6 March 2024

**Finalisation of Fairfield LEP 2013 (Amendment No.45) – Accelerated LEP Review
Stage 2 Planning Proposal**

24050046 Fairfield Town Centres Planning Proposal Flood Advice

Figure 3: Extent of Georges River flooding

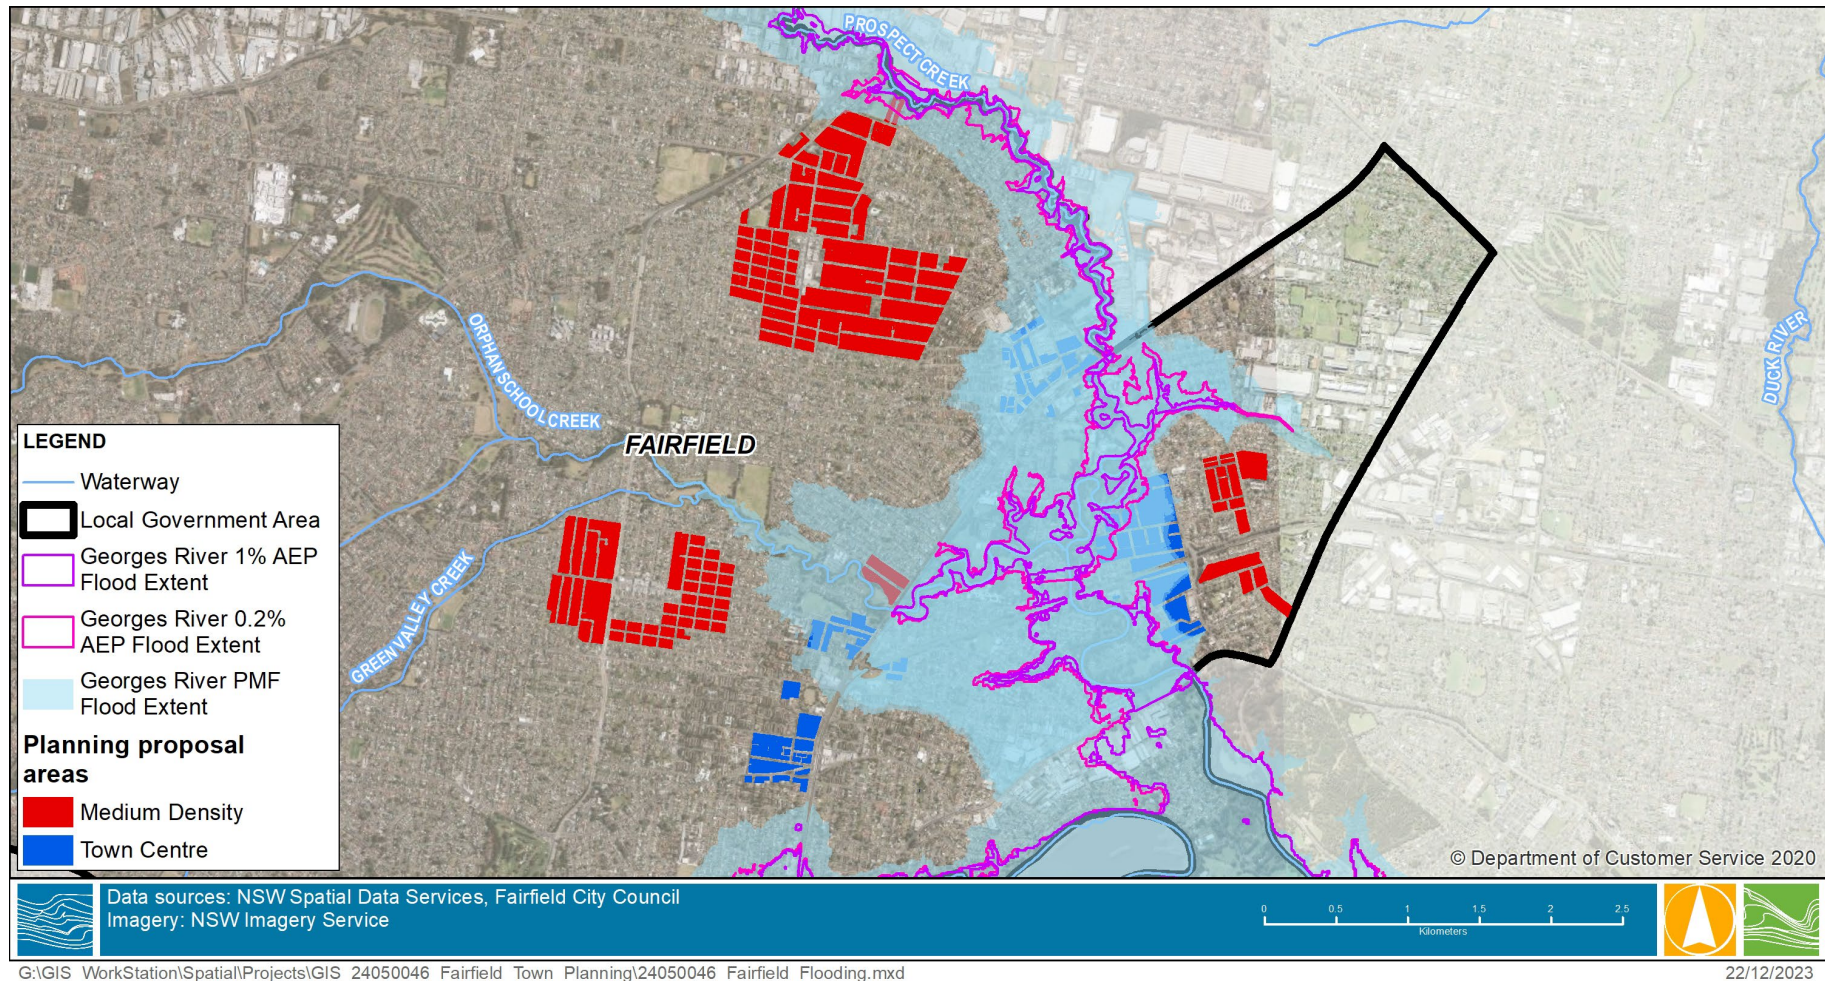
I agree that flood impacts in events greater than the 1% AEP floods do need to be considered. However, there is adequate information in the existing flood studies for this to be done. For example, Figure 3 (below) includes an extract from the Georges River Flood Study Stage 1, showing the extent of the 0.2% (1 in 500 year) AEP. As a result of the 2022 NSW Flood Inquiry, it is understood that there have been some discussions within DPHI and NSW Reconstruction Authority of considering the implications of a 0.2% AEP flood planning level in high-risk catchments such as the Hawkesbury Nepean and Northern Rivers.

Figure 3 shows the extent of flooding from the Georges River in Fairfield and adjoining LGAs and tributary catchments. Parts of Canley Vale, Fairfield Town Centre, and Carramar are within the extent of Georges River flooding. Fairfield Heights, Fairfield East, Smithfield, Canley Heights, Cabramatta and Villawood are only affected by creek flooding and/or overland flows.

I therefore agree that evacuation modelling of those areas which are potentially affected by Georges River flooding is appropriate. It would need to consider the interaction of evacuation traffic from existing development with that from the proposed planning areas. There is already a flood evacuation model for Georges River flooding in the Liverpool LGA and it includes sufficient information to estimate how much time is available for evacuation from flooding. It could easily be extended to cover the Fairfield LGA. While evacuation modelling can be a complex and expensive exercise, there are ways of undertaking some preliminary analysis at lesser cost to determine whether evacuation is feasible. The detailed modelling can then focus on those areas where more detailed modelling is required.

Figure 4: Evacuation Centres in Georges River Catchment

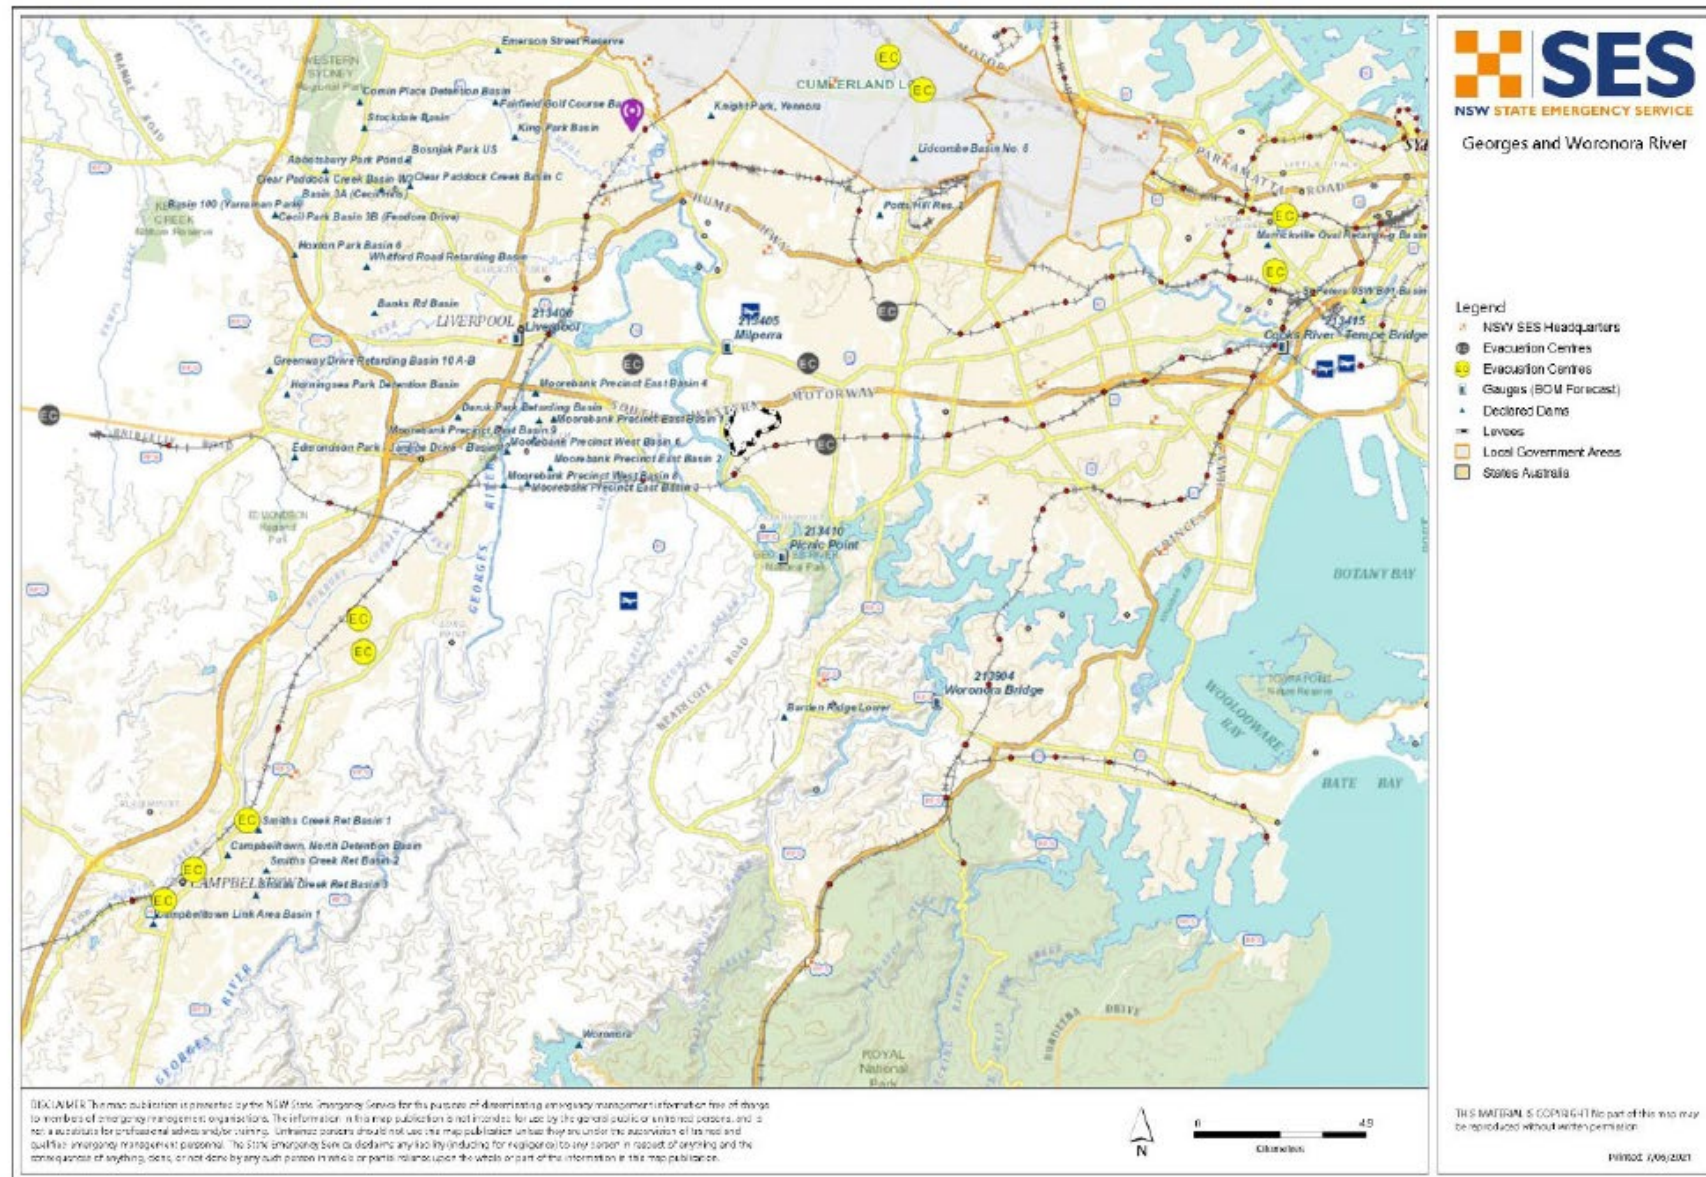
Figure 4 shows potential flood evacuation centres within the Georges River catchment as identified in NSW SES local and regional emergency plans. None are within the Fairfield LGA and therefore none can be reached by people within most of the LGA without the need to get across one or more of the creeks within the LGA. These creek crossings flood in events more frequent than the 0.2% AEP flood which the NSW SES considers to be a suitable flood immunity for regional evacuation routes. Therefore evacuation out of most of Fairfield LGA during a flood is not a practical option.

Therefore, to adequately cater for those who need to evacuate from existing dwellings, let alone any new dwellings, and to reduce the chance of people driving through floodwaters to get to them, some local evacuation centres would need to be established. Figure 5 shows some suggested locations and evacuation routes to them from those who may have to evacuate ahead of Georges River flooding in Fairfield LGA. The routes shown would not only avoid creek crossings but also mostly avoid overland flow paths and therefore provide reliable evacuation routes for evacuees.
